MITIGATION PLAN

ROSES CREEK STREAM MITIGATION SITE

Burke County, North Carolina
NCDMS Project No. 96309

**RE: DENR – Division of Mitigation Services
Roses Creek Stream Mitigation Site
Response to IRT Comments on the Draft Mitigation Plan (September 14, 2015)**

Figure 13

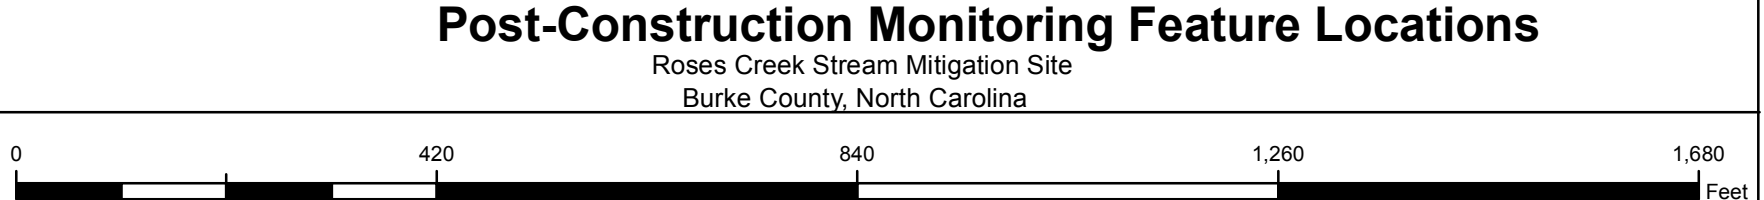
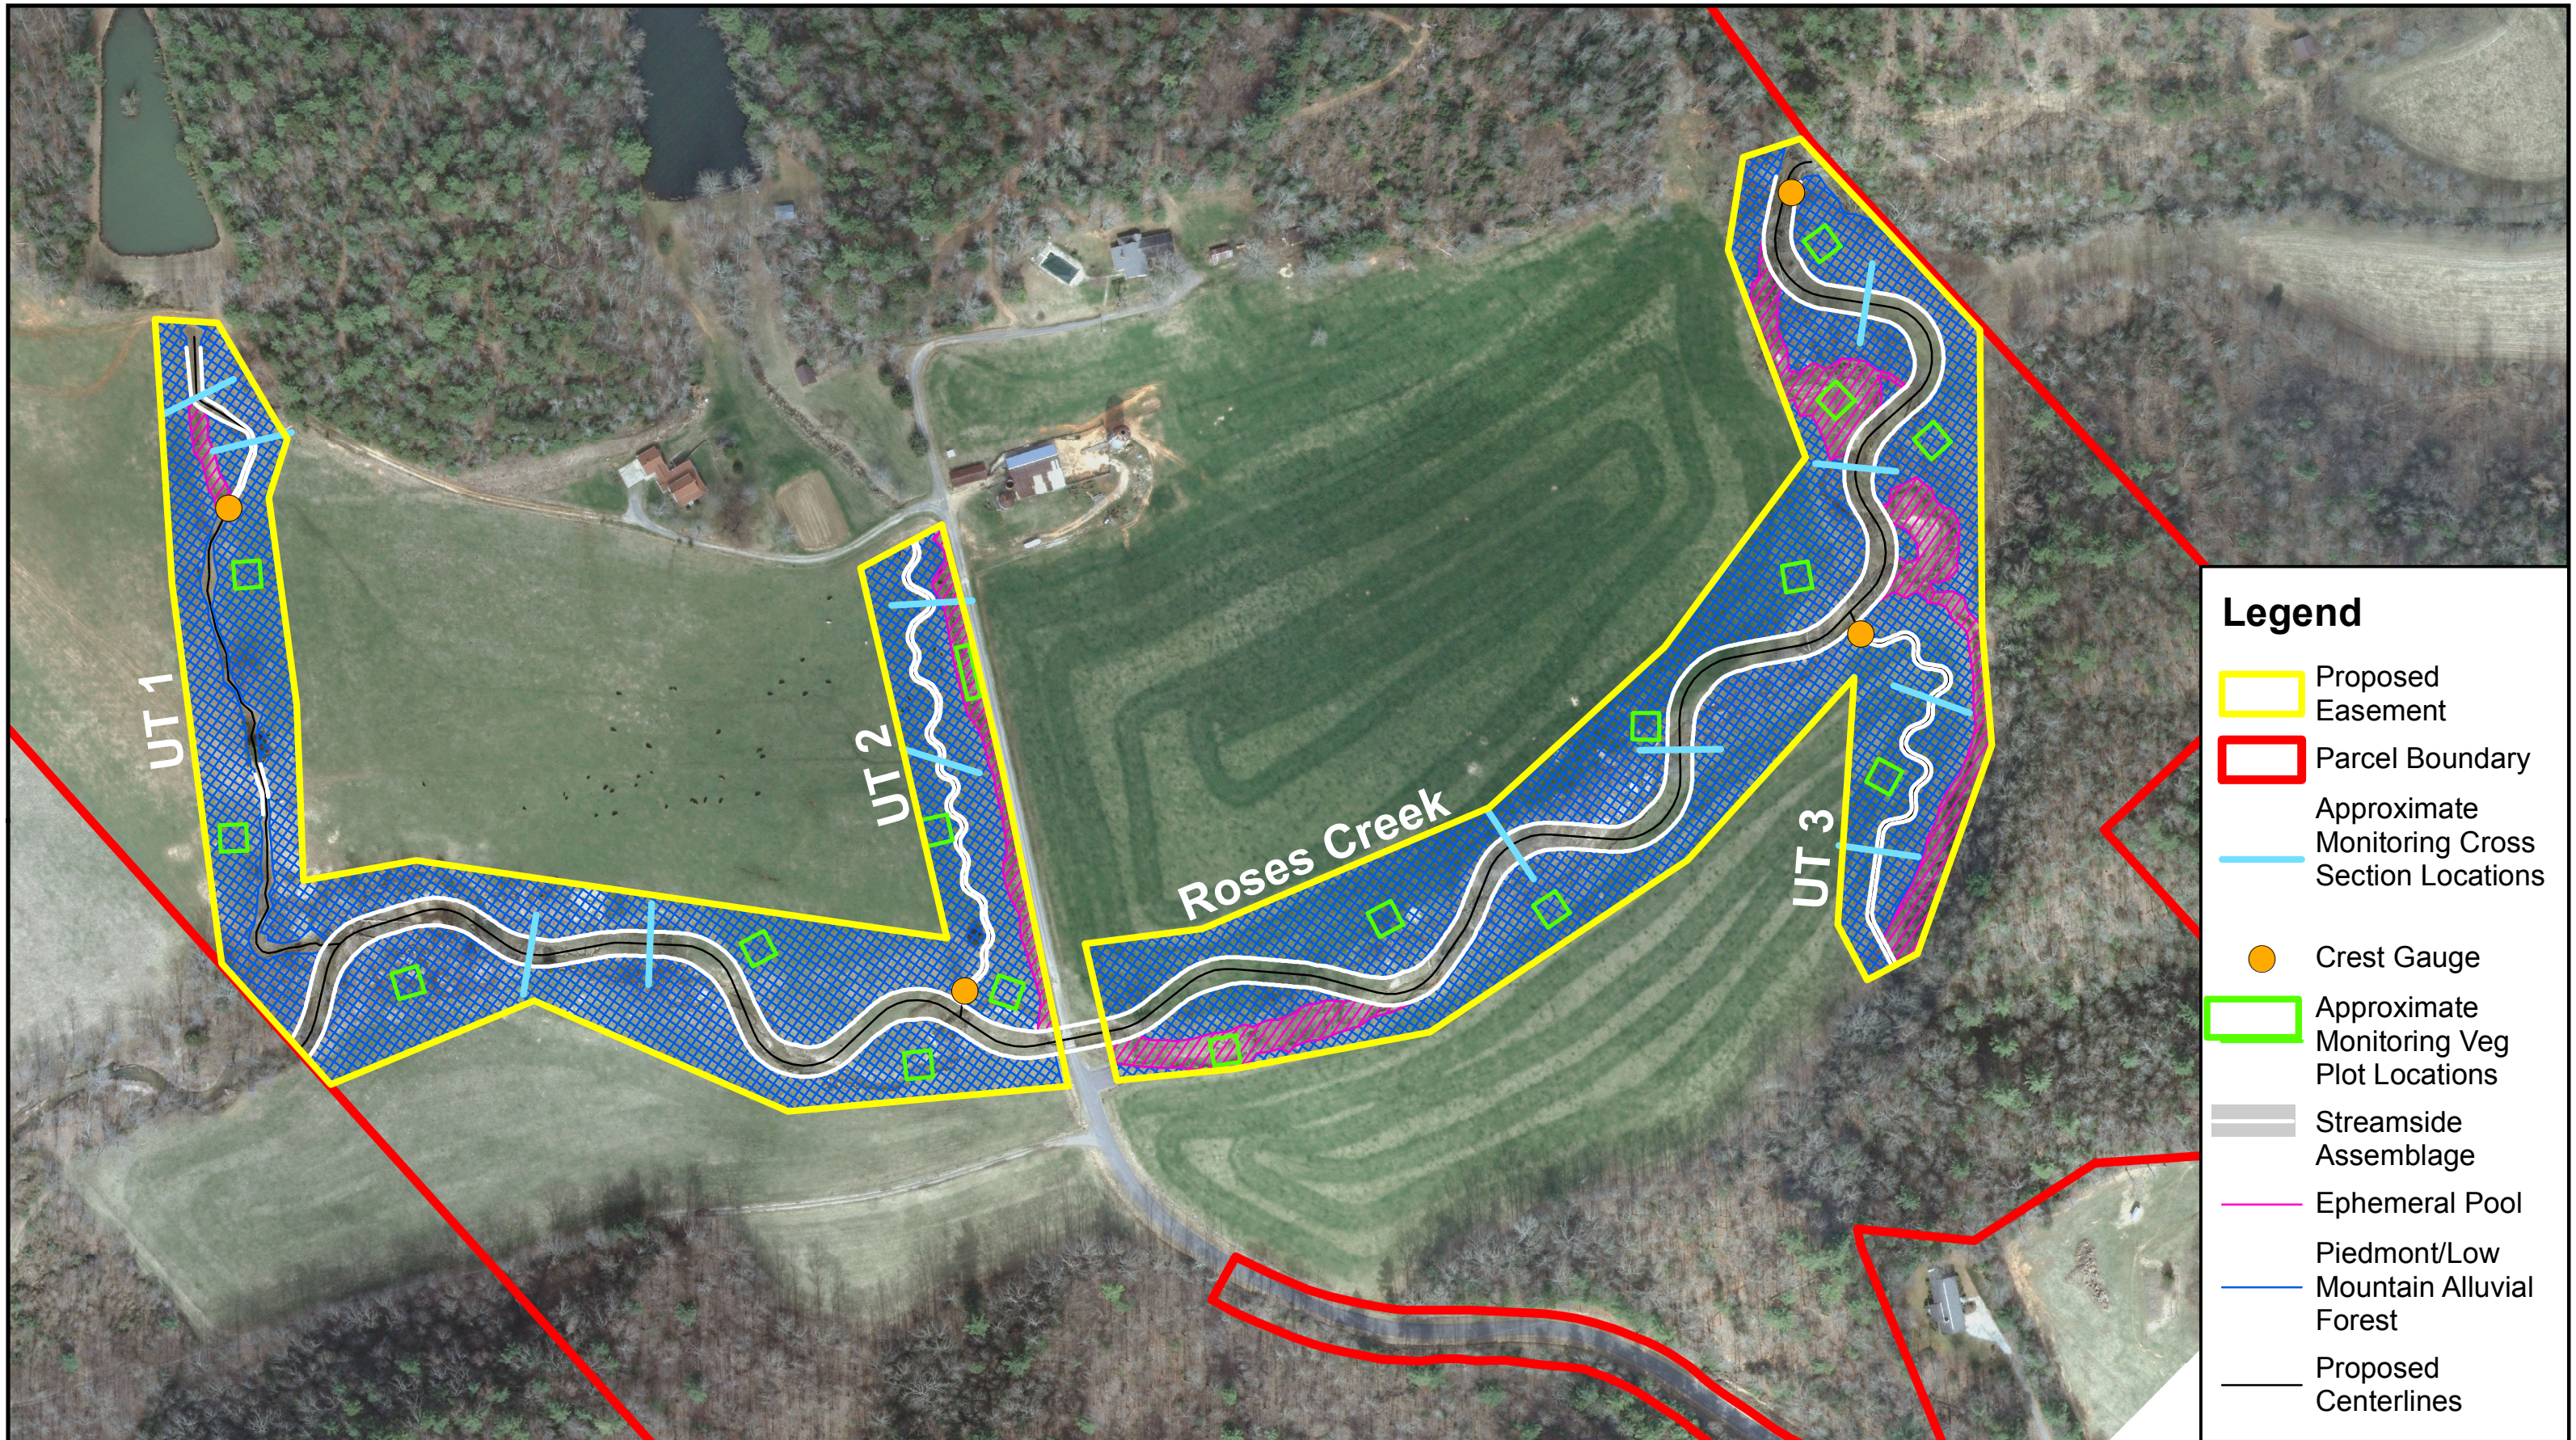
B. *Please locate the “approximate” location of the proposed 17 monitoring vegetation lots on Figures PL-1 and PL-2. Planting plots should be located in both the floodplain zone and ephemeral pool planting zones.*

- G. *Other: The plan includes a map of pre-monitoring locations. Please submit a map depicting the approximate locations of proposed post-construction monitoring stations with the final mitigation plan.*

Response: Comply. Figure 13 has been added to the plan to document the anticipated location of monitoring features including vegetation plots, cross sections, crest gauges and surface water gauges.

Response: Comply. Figure 13 has been added to the plan to document the anticipated location of monitoring features including vegetation plots, cross sections and crest gauges.
